## AMENDMENT #1

No. PCCD-15-PCW6-01

**IFB No. PCCD-15-PCW6-01 – Plum Creek Watershed FRS Site 6 Rehabilitation**

## **PEN-AND-INK CHANGES / Revised Page / Clarifications**

Reference Drawing TX-EN-0650 Sheet C-2

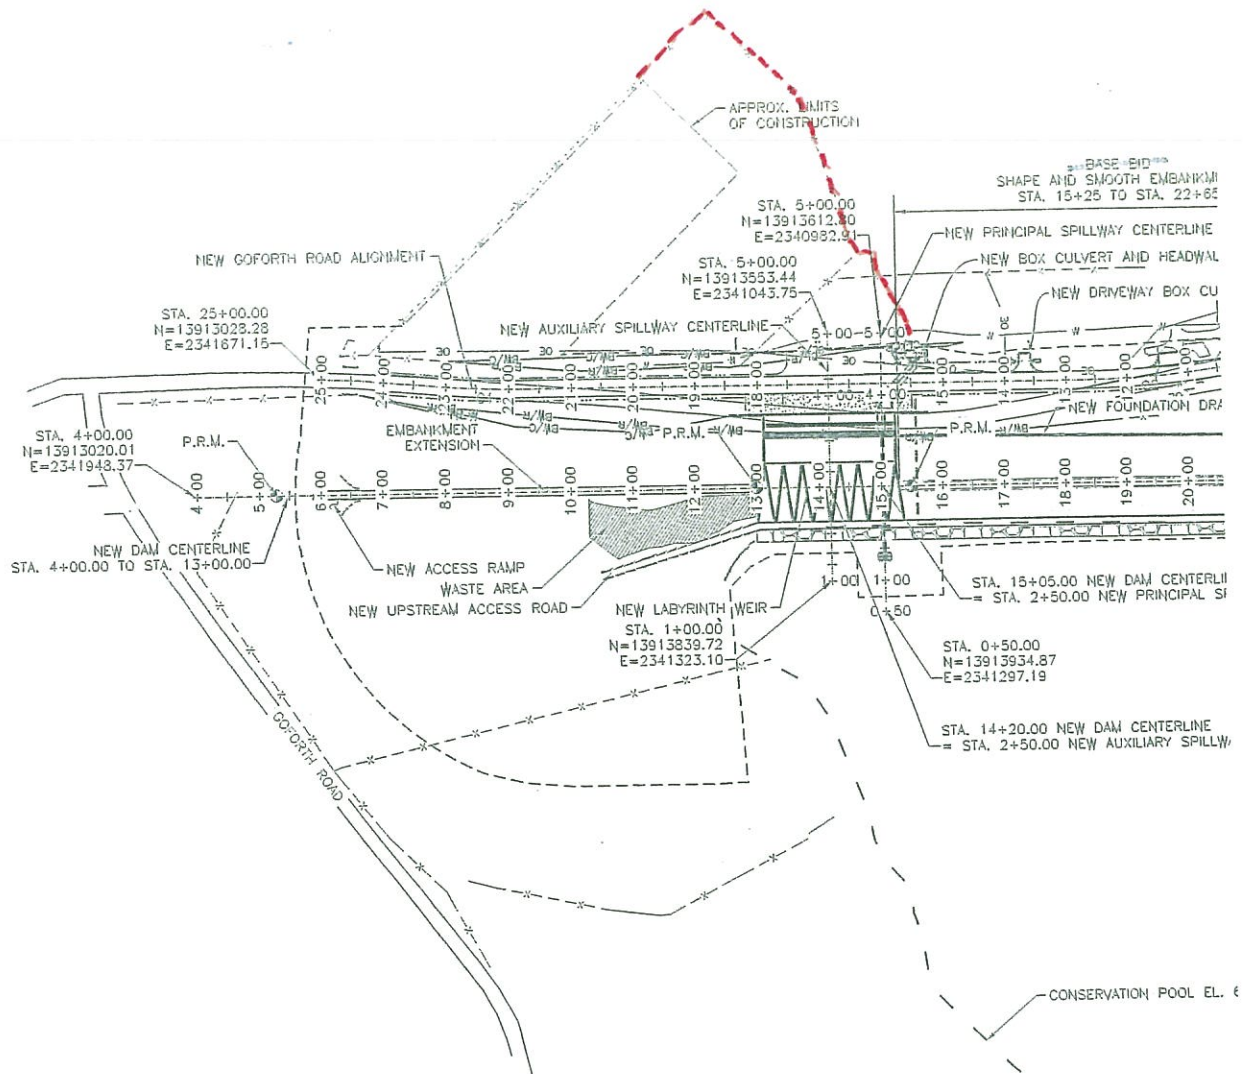
Sheet C-2. The Limits of Construction shall be changed south of Goforth Rd to include all of the existing Auxiliary Spillway and from the downstream fence corner on the right side of the auxiliary spillway facing downstream, then NW to the creek, then along the creek NE to the existing outlet structure. A sketch of this change is attached to this Amendment #1.

Red = Change in limits of construction.
